Technical Service Information

THM 440-T4

2ND CLUTCH DURABILITY (CLIP BOOST SPRING)

Figure 1

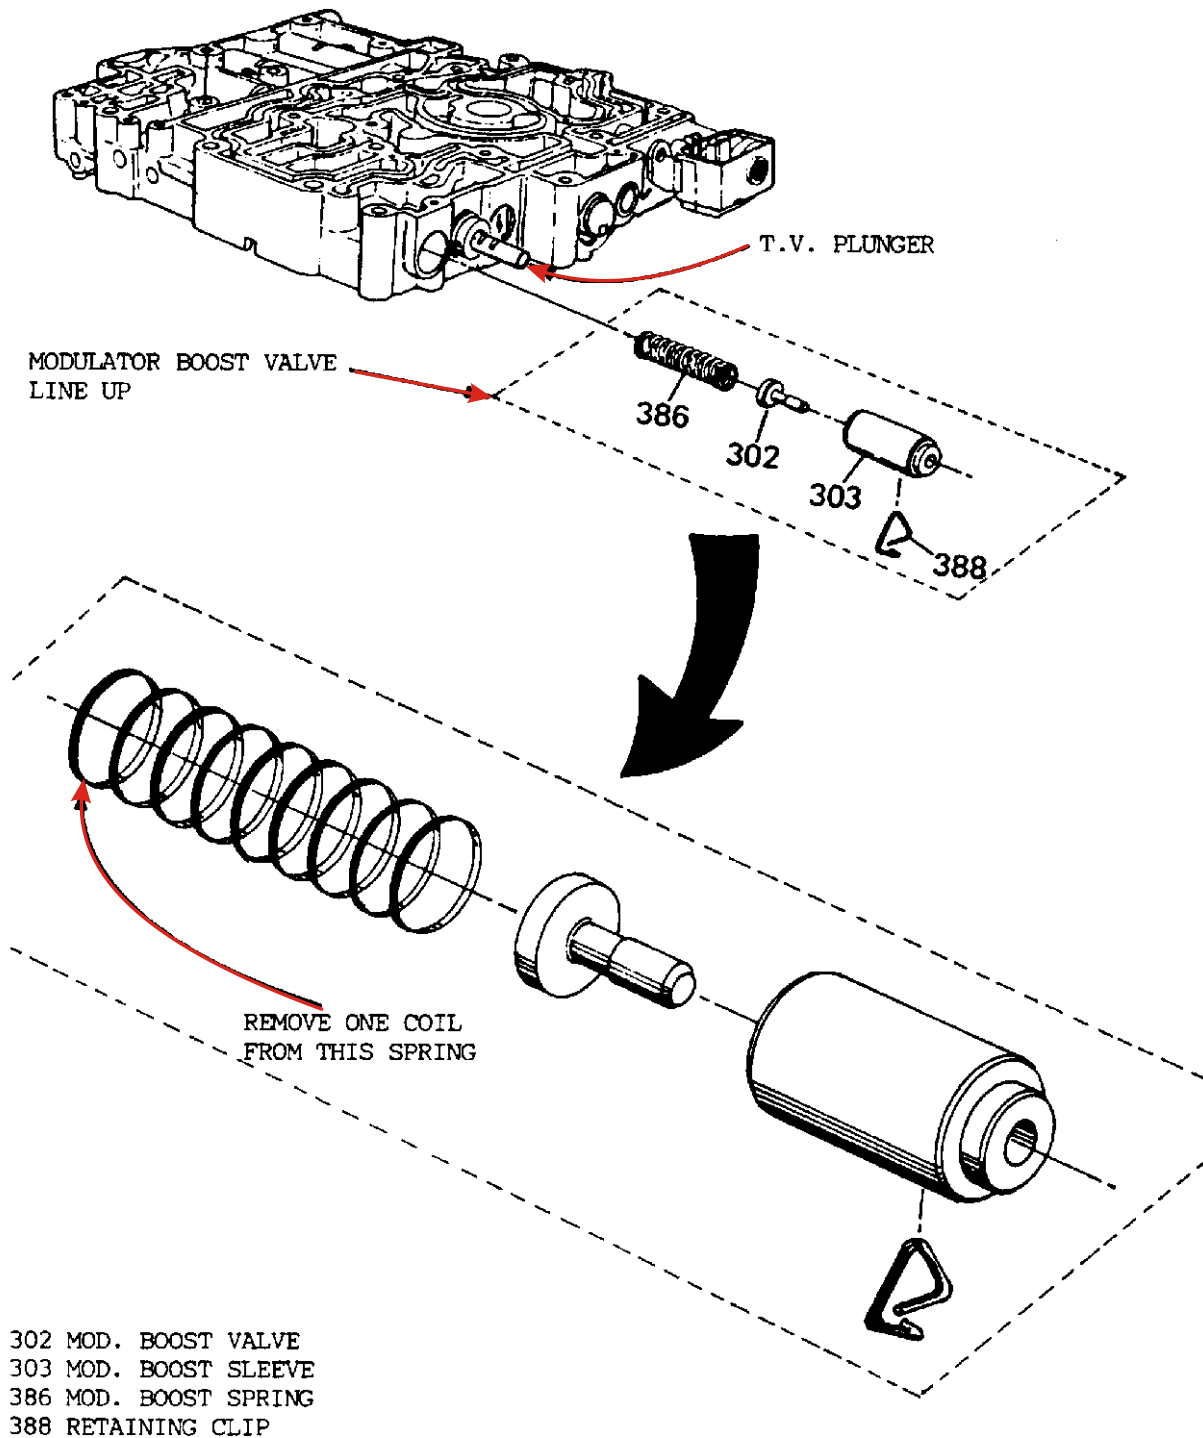
COMPLAINT: 2nd clutch pack with a very short life span, usually associated with a 1-2 slip, or a 1-2 slide bump.

CAUSE: The cause may be a lack of line pressure to sufficiently apply the 2nd clutch pack.

CORRECTION: Shorten the modulator boost valve spring by 1/8", or approximately 1 coil. The modulator boost valve spring is located in the pressure regulator line up, which is directly next to the T.V. plunger in the valve body (See Figure 1). This will allow line pressure to rise at less of a throttle opening and greatly increase 2nd clutch durability. This modification should be done on all THM 440-T4 transaxles during the rebuilding process.
